Addendum 78 – UN Regulation No. 79

Revision 3 –Amendment 2

03 series of amendments – Date of entry into force: 16 October 2018

Uniform provisions concerning the approval of vehicles with regard to steering equipment

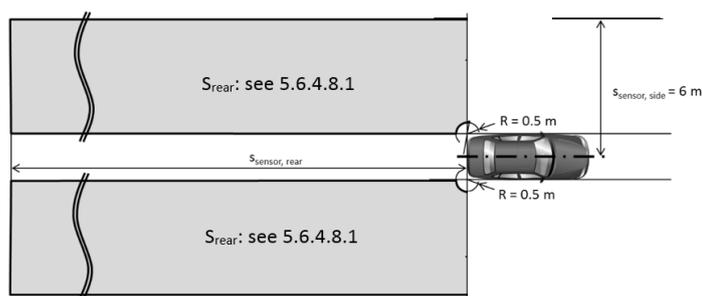
5.6.4.8.2. The vehicle system detection area on ground level shall be at minimum as shown in the figure below.
